H.B. ROBINSON STEAM ELECTRIC PLANT, UNIT NO. 2

DOCKET NO. 50-261

RESPONSE TO OVERPRESSURE PROTECTION QUESTIONS

LOGIC DIAGRAM FOR
OVERTEMP PROTECTION

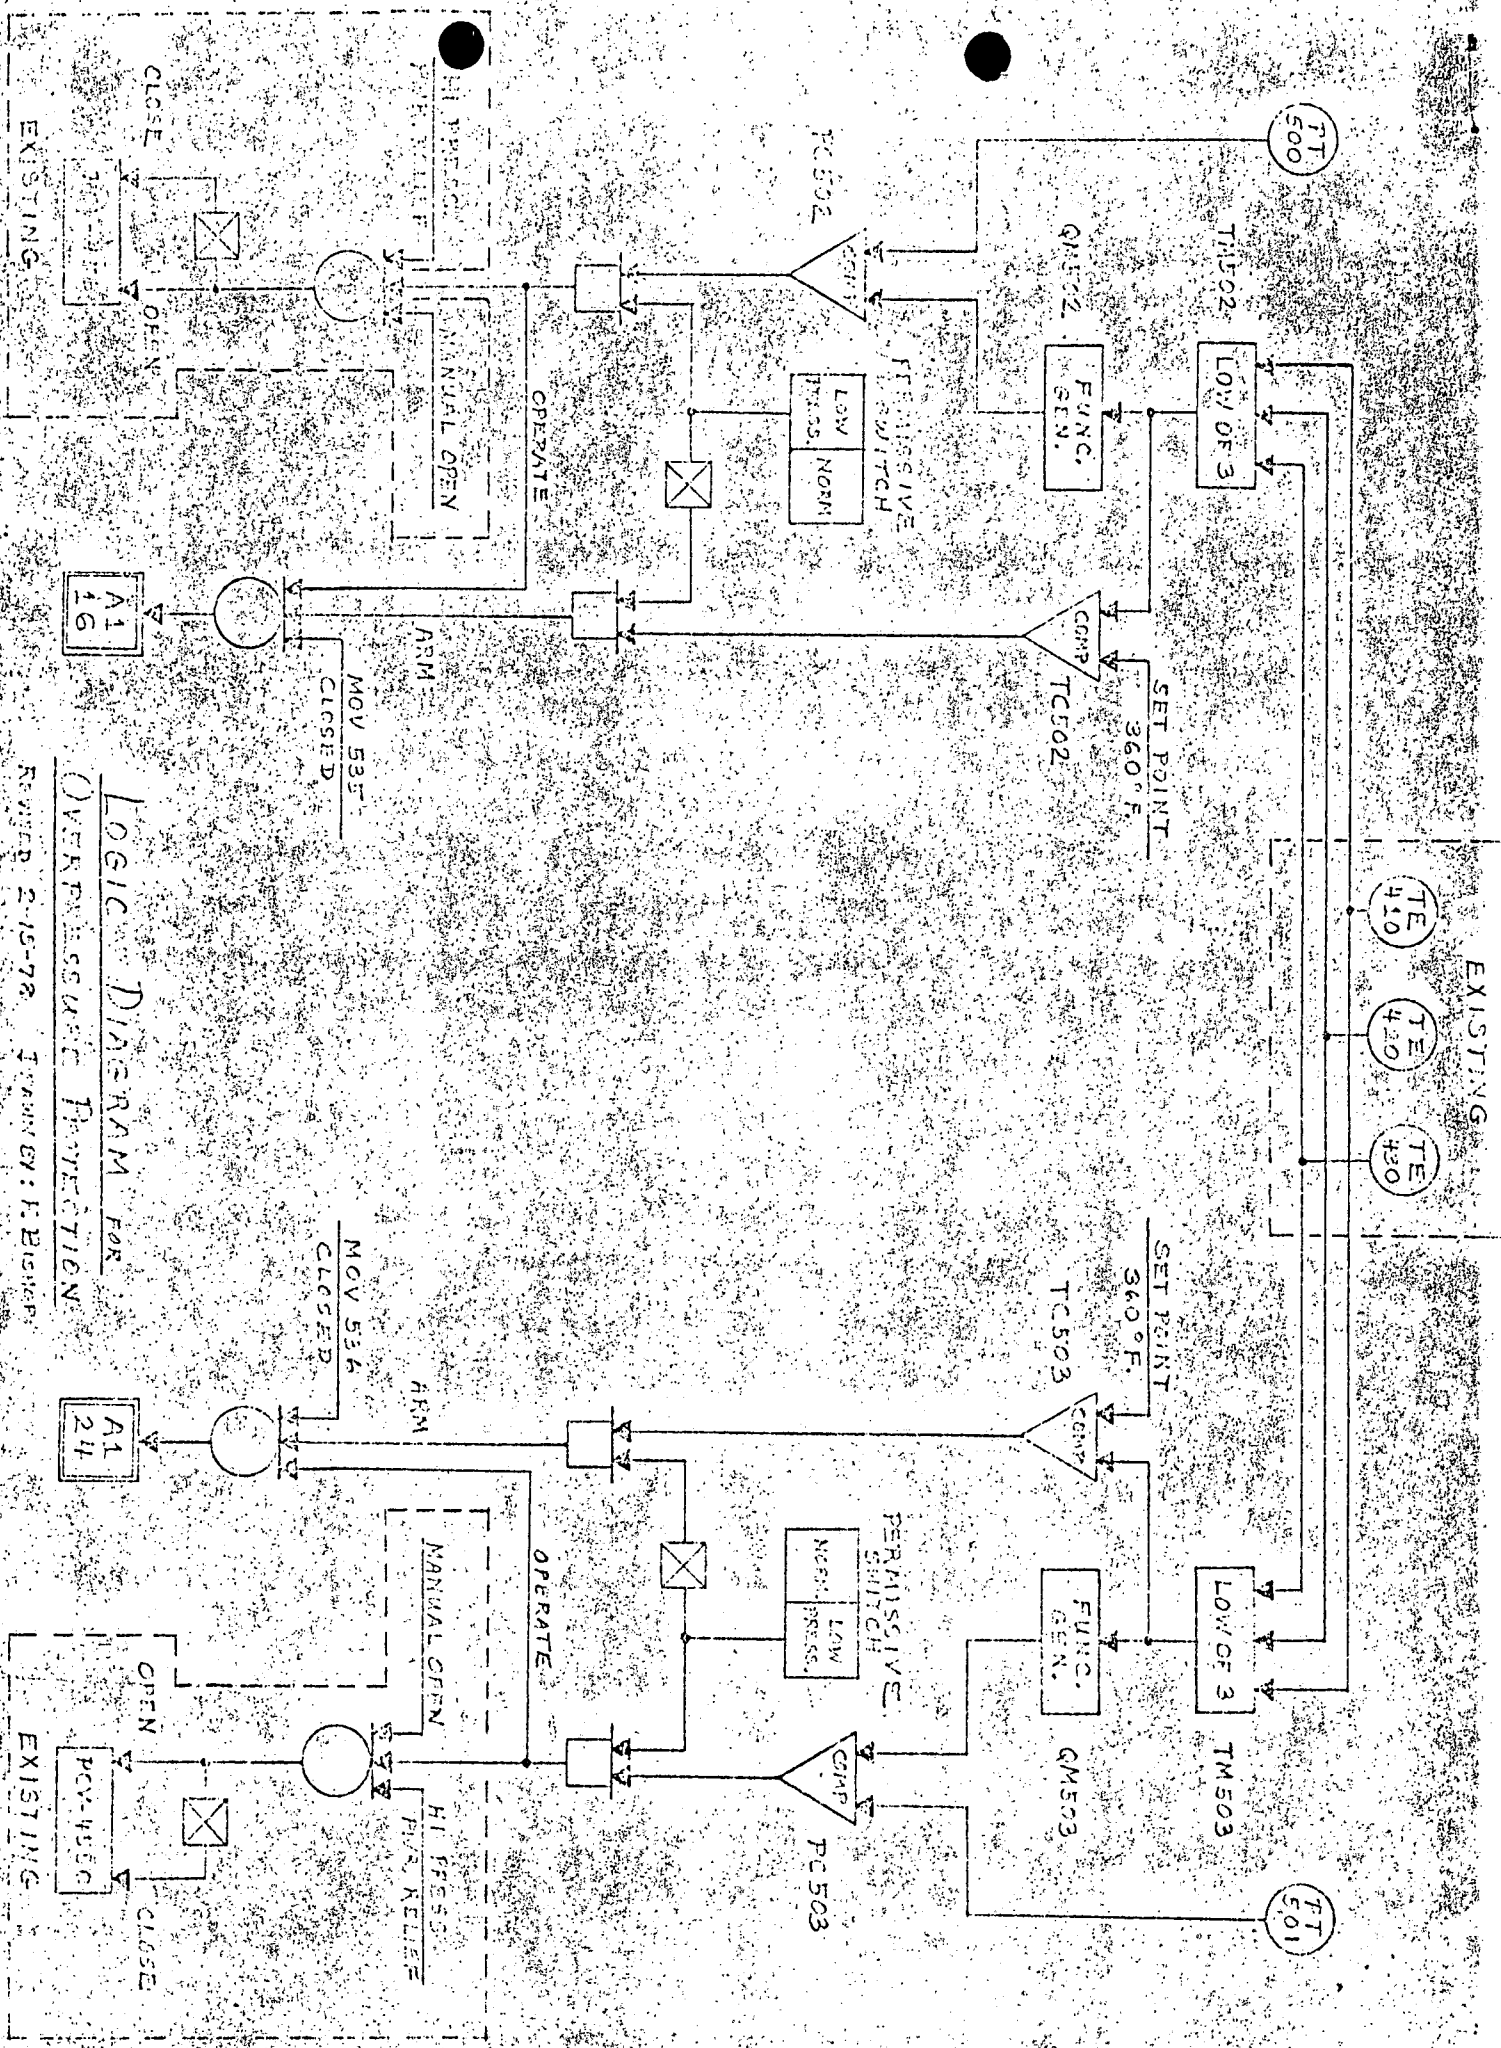
QUESTION 2

A clearer representation would be given by the "operate" input to annunciator being drawn from the AND gate preceeding the OR gate shown.

Other annunciators are used for the high pressure valve actuating circuitry. Warning of high pressure conditions prior to an actual valve lift is given by annunciators A3-23, A3-32, A3-30, A3-38, and A3-16. Actual lift is indicated by A3-8, "Pressurizer Protection, High Pressure."

Westinghouse Electric Corporation										500B 452	
TITUS CATHODE POWER & LIGHT CO.										SHEET 120-1	
115 ROUTING STEAM PLANT - UNIT NO. 1											
ELEMENTARY WIRING DIAG. PER REV. 1											
SHEET 120-1											
ATOMIC POWER DIV.										PITTSBURGH, PA. U.S.A.

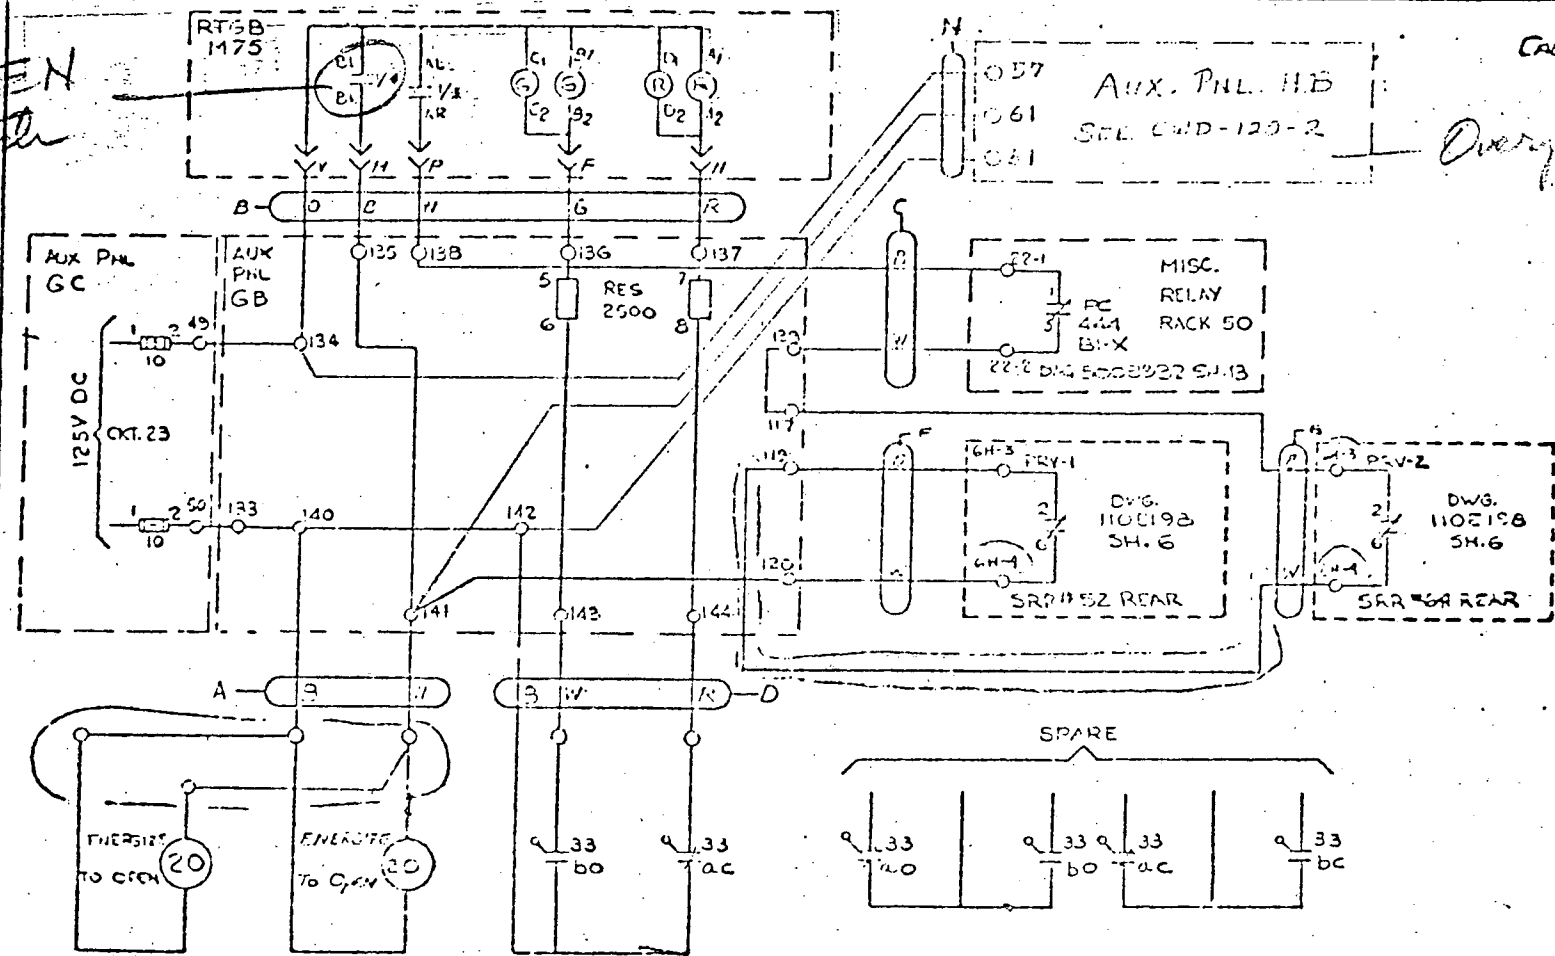
QUESTION 1

The attached H. B. Robinson Plant Control Wiring Diagrams numbered 119 and 120 show the other control functions. This is consistent with CP&L procedure to use one wiring diagram for each complex function of a multifunction device. Hence, the Overpressure Wiring Diagram in our previous submittals shows only that complex function.

* Circuits behind these relays drive other announcements
These are 2/3 High Pressure control
